SUBJECT: ISSUANCE OF AMENDMENTS (TAC NOS. 61670 AND 61671)

PACIFIC GAS AND ELECTRIC COMPANY
DIABLO CANYON NUCLEAR POWER PLANT, UNIT 1
DOCKET NO. 50-275
AMENDMENT TO FACILITY OPERATING LICENSE

ATTACHMENT TO LICENSE AMENDMENT NOS. 24 AND 23
FACILITY OPERATING LICENSE NOS. DPR-80 AND DPR-82
DOCKET NOS. 50-275 AND 50-323

SAFETY EVALUATION BY THE OFFICE OF NUCLEAR REACTOR REGULATION
RELATED TO AMENDMENT NO. 24 TO FACILITY OPERATING LICENSE NO. DPR-80
AND AMENDMENT NO. 23 TO FACILITY OPERATING LICENSE NO. DPR-82
PACIFIC GAS AND ELECTRIC COMPANY
DIABLO CANYON NUCLEAR POWER PLANT, UNIT NOS. 1 AND 2
DOCKET NOS. 50-275 AND 50-323

FIGURE 5.1-3
MAP DEFINING UNRESTRICTED AREAS AND SITE BOUNDARY
FOR RADIOACTIVE GASEOUS AND LIQUID EFFLUENTS

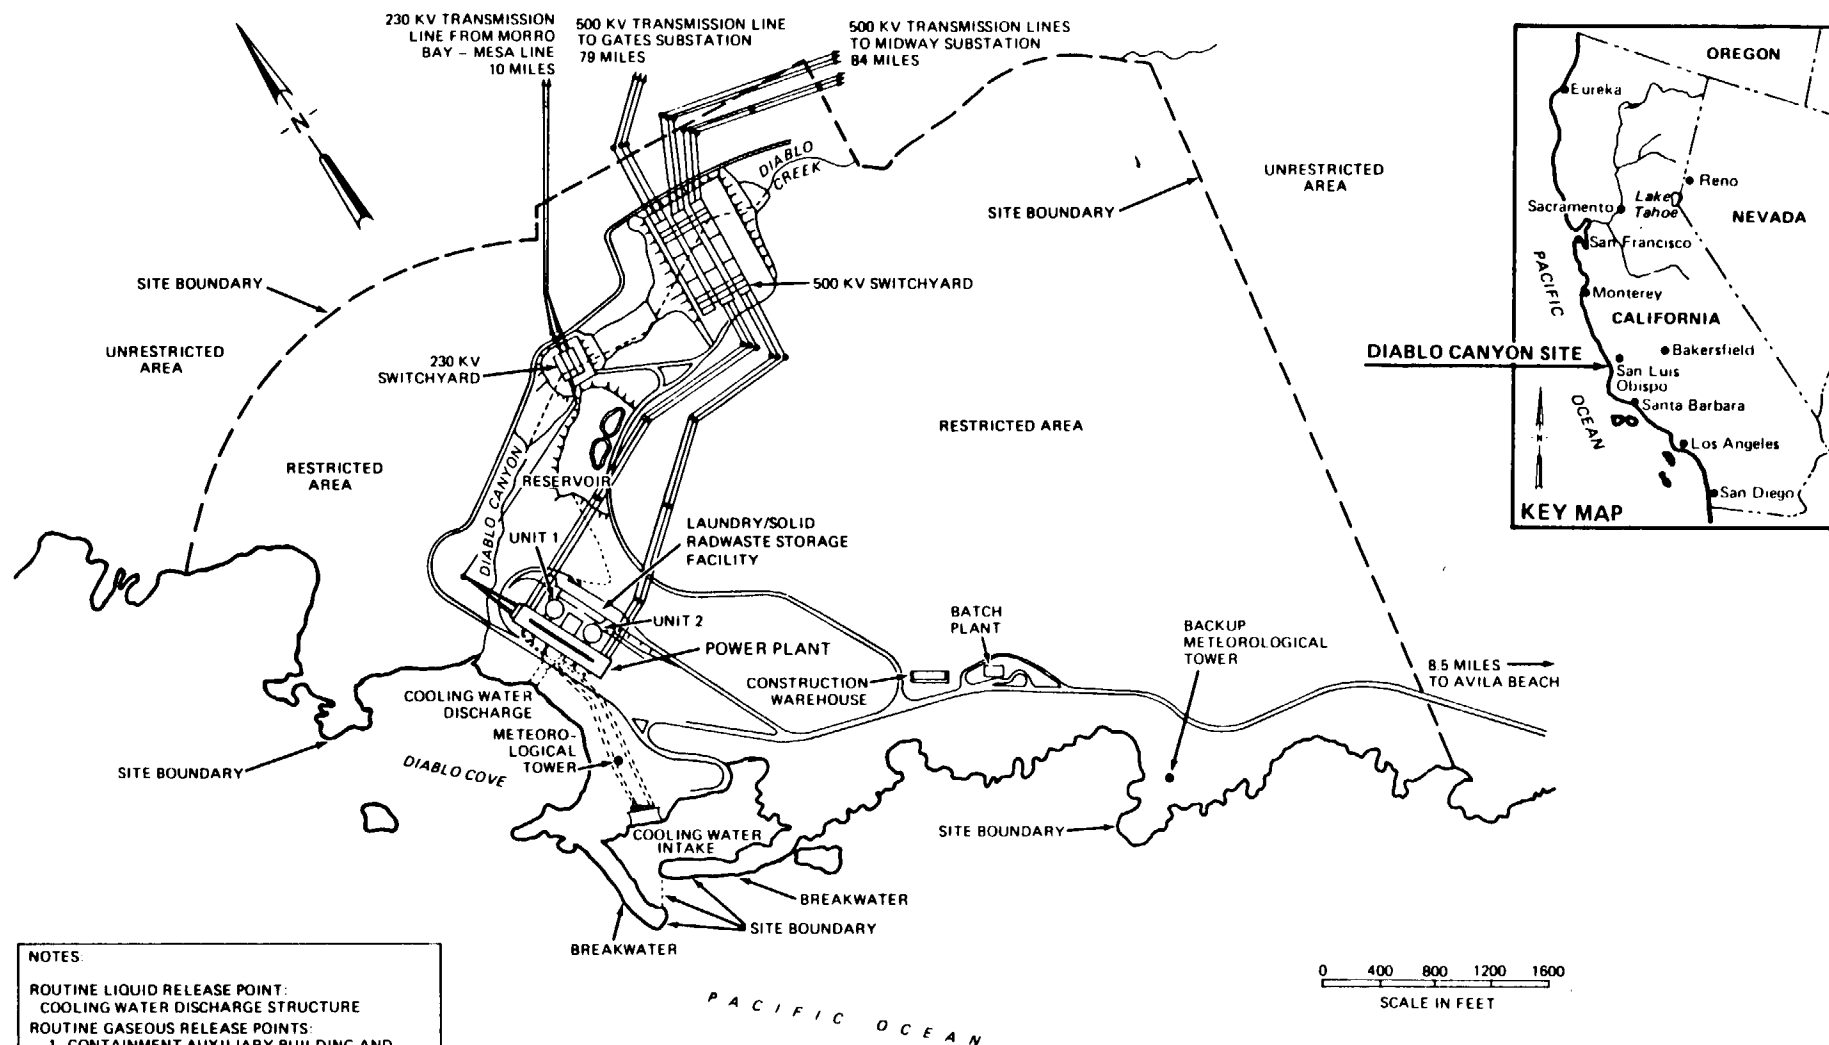
These amendments add the laundry and solid waste storage facility to Figure 5.1-3 to identify this facility as a routine radioactive gaseous release point.

In the amendment request, PG&E proposes to add the laundry/radwaste storage facility to Figure 5.1-3, as requested. This is acceptable since the figure would now correctly show this facility.

- NOTES:
- ROUTINE LIQUID RELEASE POINT:
COOLING WATER DISCHARGE STRUCTURE
- ROUTINE GASEOUS RELEASE POINTS:
1. CONTAINMENT AUXILIARY BUILDING AND FUEL HANDLING BUILDING EXHAUSTS. TOP OF CONTAINMENT STRUCTURE AT ELEVATION 328 FEET
 2. TURBINE BUILDING: TOP OF TURBINE BUILDING AT ELEVATION 148 FEET
 3. STEAM GENERATOR BLOWDOWN TANK VIA A VENT AT THE TOP OF THE AUXILIARY BUILDING AT ELEVATION 187 FEET.
 4. LAUNDRY/SOLID RADWASTE STORAGE FACILITY: VIA VENTS AT ELEVATIONS 138 FEET AND 157 FEET.
